**NOTICE OF PREPARATION OF A
DRAFT ENVIRONMENTAL IMPACT REPORT FOR THE
NATIONAL CITY CARMAX AND HOTEL PROJECT**

Project Title: National City CarMax and Hotel Project

CarMax and Hotel Project, National City
 NOP/SCH#2016111035

**Subject: Comments on the Notice of Preparation of a Draft Environmental Impact Report
for the National City CarMax and Hotel Project SCH# 2016111035**

National City Car-Max and Hotel Project Existing Easement and Water Facilities

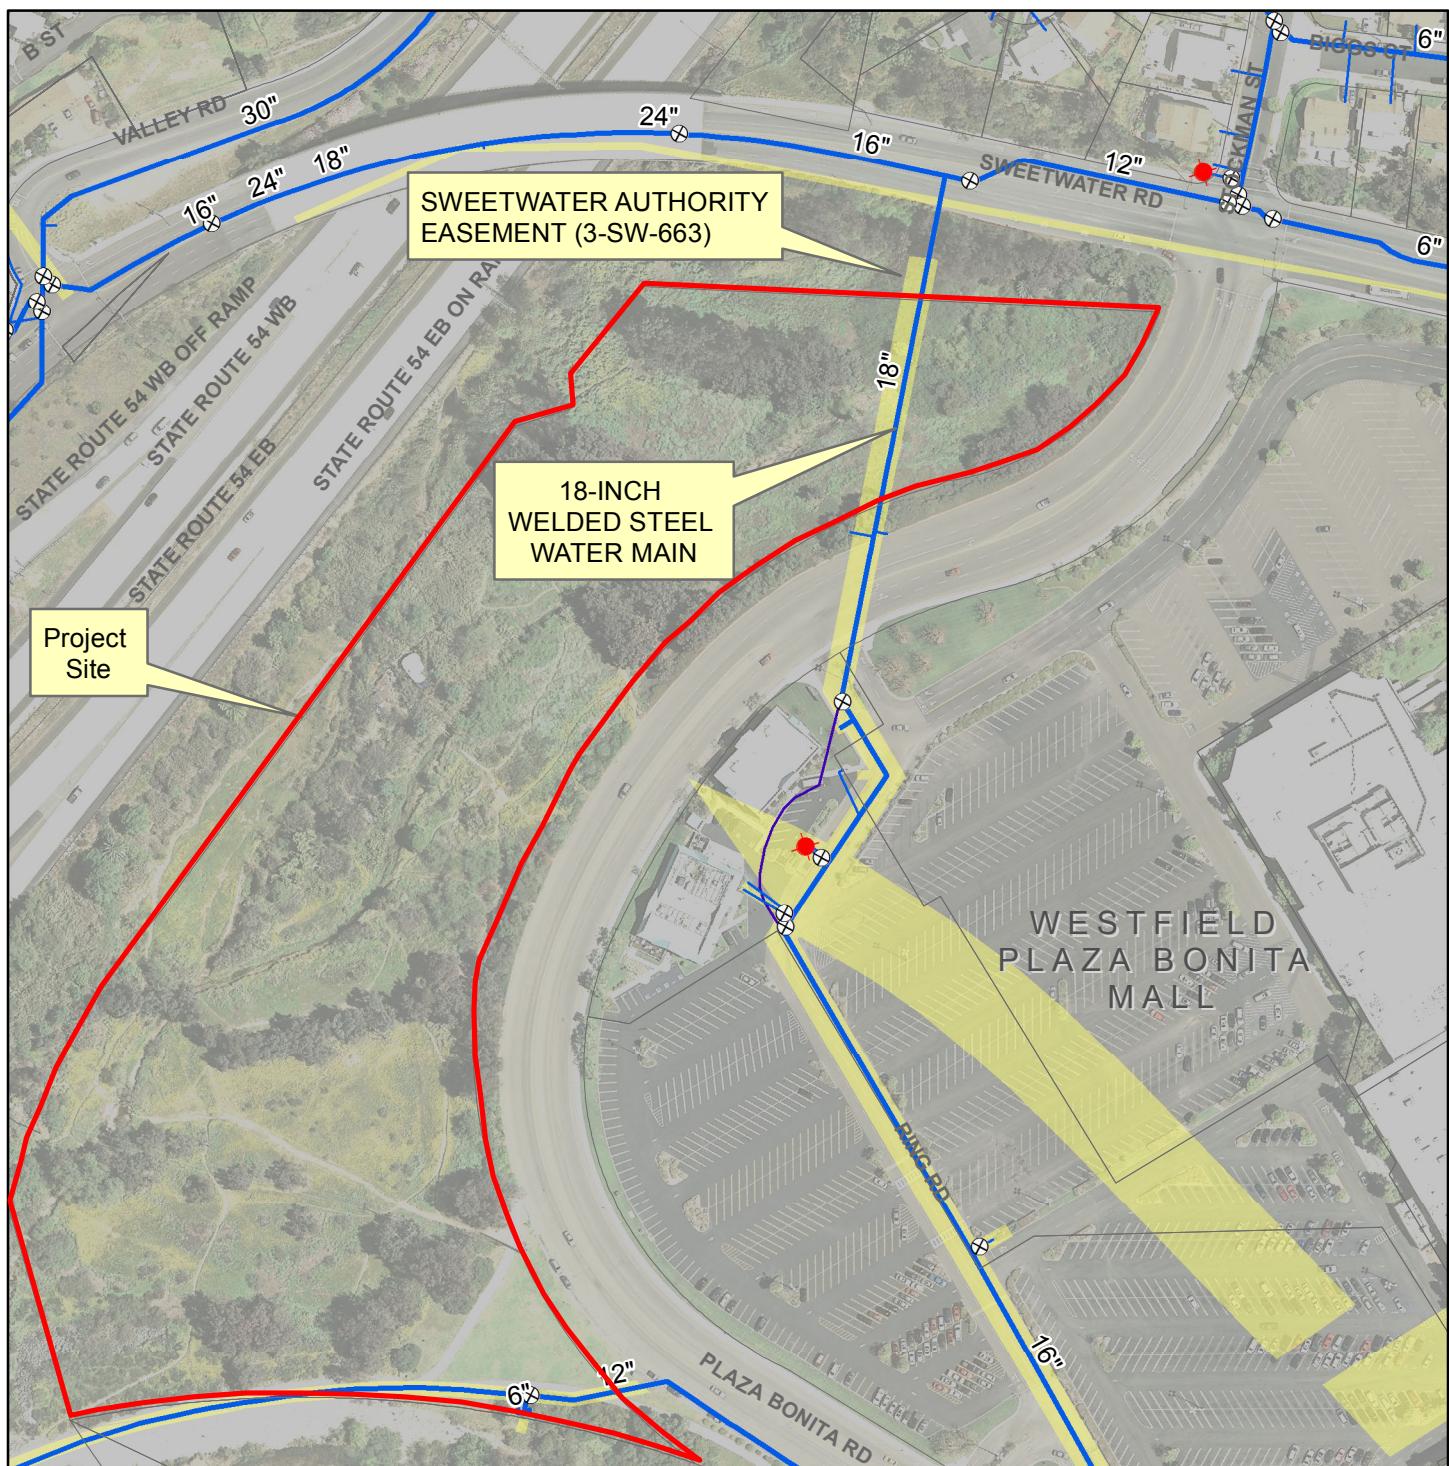
Sweetwater Authority (Authority) has received a Notice of Preparation (NOP) of a Draft Environmental Impact Report (DEIR) for the above-referenced project, within the City of National City. It is understood that the project is on a 15.08 acre site near the southeast corner of the Interstate 805 and State Route 54 interchange, and will involve the construction of an automobile dealership, grading to accommodate a potential future hotel, and re-contouring of the unnamed tributary over the subject parcel. It is further understood that the project will require General Plan, Zoning, and Land Use Code amendments to allow for the proposed uses. It is to be noted that the Authority owns and operates an 18-inch welded steel water transmission main located within a 30-foot wide easement over the subject parcel, as shown on the enclosed Exhibit A.

Exhibit B
 Assessment Map Showing 2,5, and 10-Year
 Groundwater Protection Zones for the San Diego
 Formation and Alluvial Aquifer Wellfields

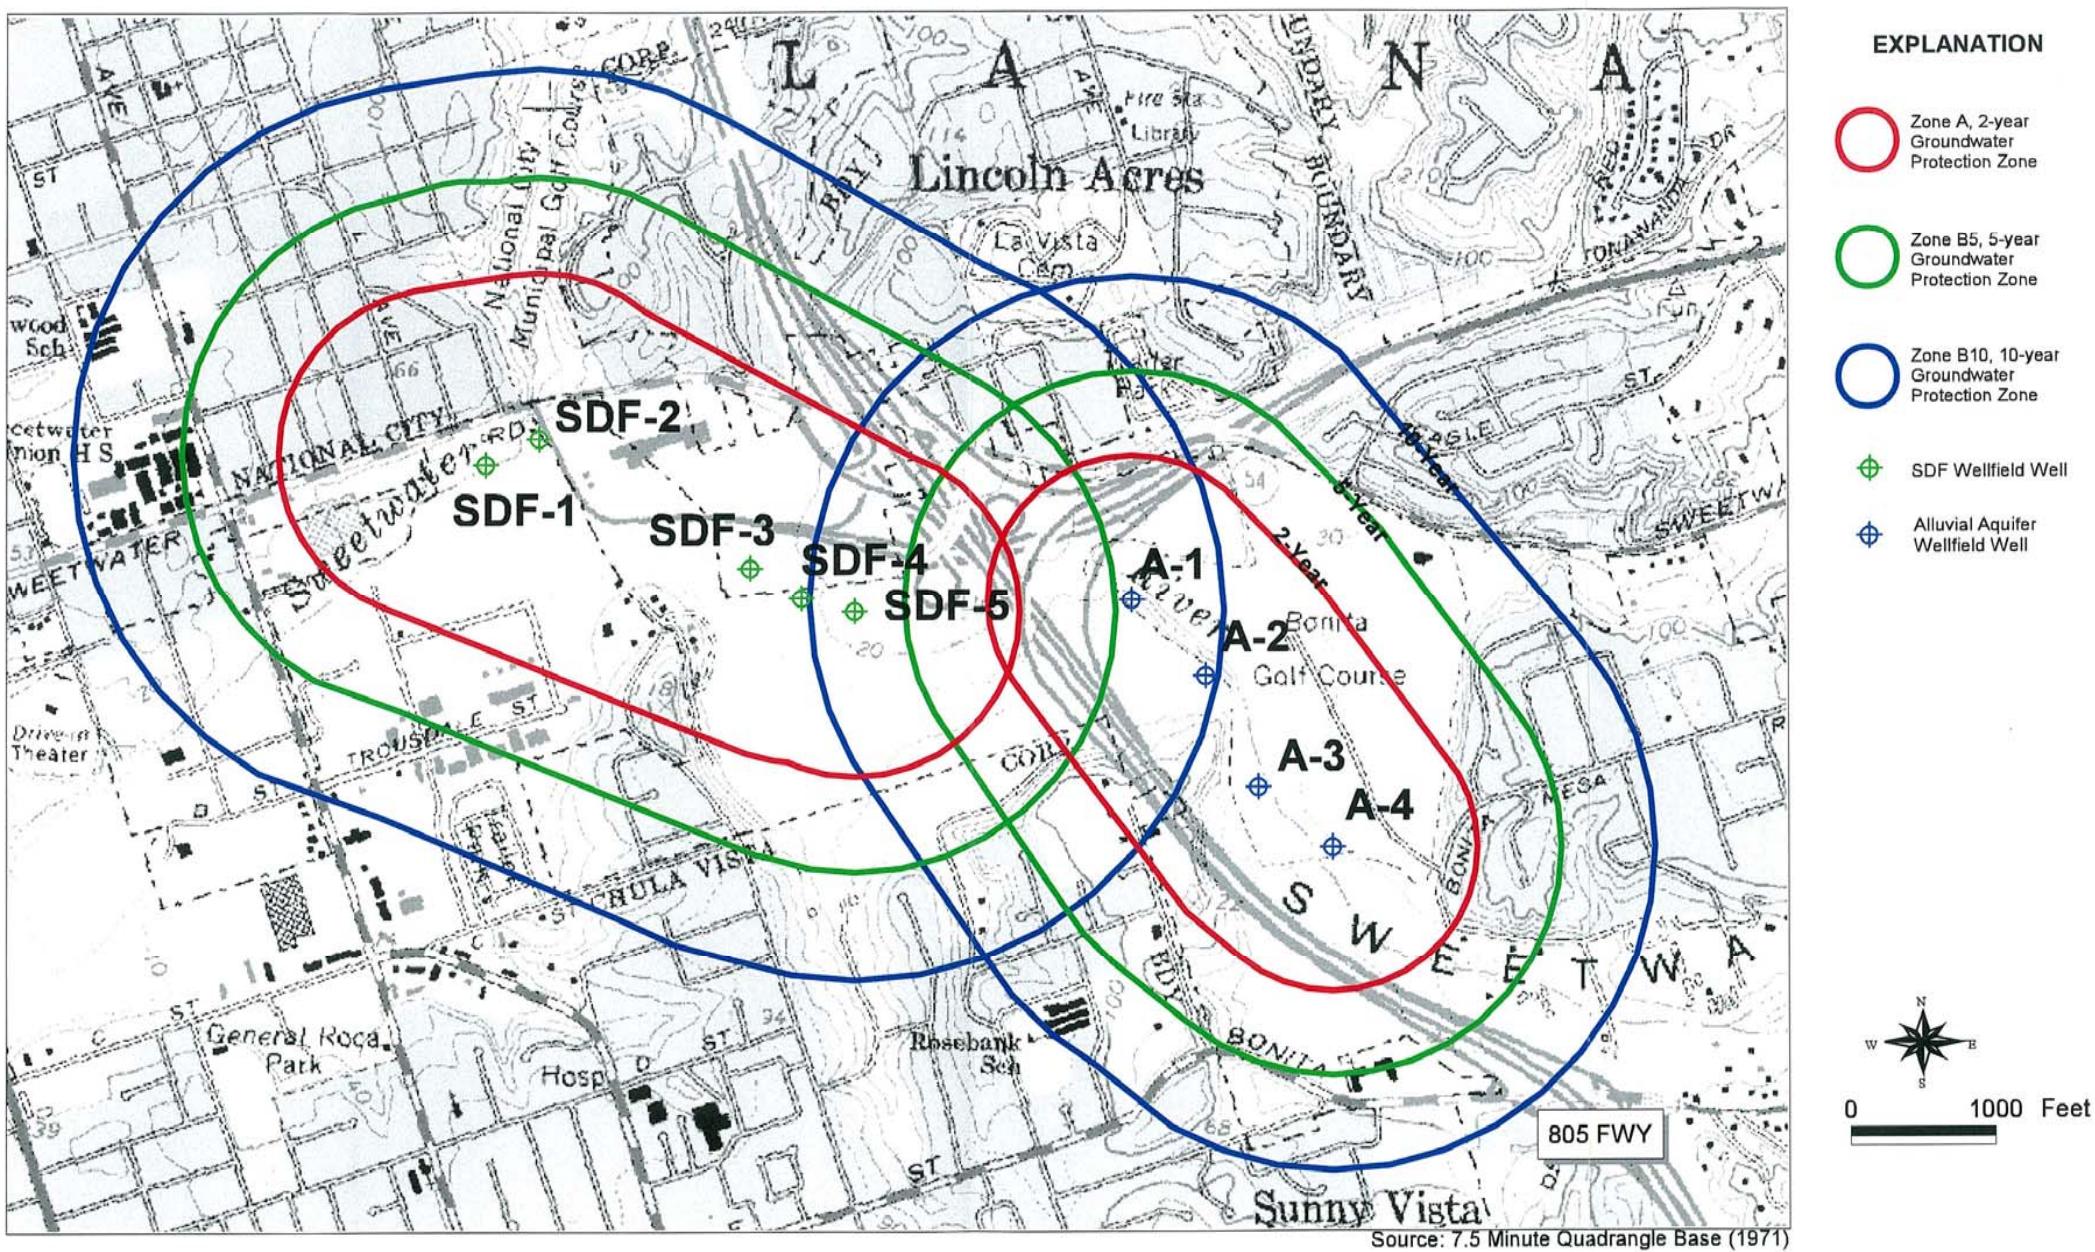
- Stormwater runoff from the project site may be subject to treatment at the Authority's Desalination Facility, due to the project's proximity to the facility's source groundwater wells. The Authority has identified and delineated groundwater protection zones, presented in Exhibit B, in relation to its groundwater wells. The Authority encourages the development of alternatives that would not include high or very high risk PCAs within the groundwater protection zones.
- The project may result in significant hydrological modifications to the area by simultaneously decreasing infiltration and increasing urban runoff. The DEIR shall consider the use of alternative construction materials and/or Low Impact Development (LID) systems and practices, such as permeable pavement or
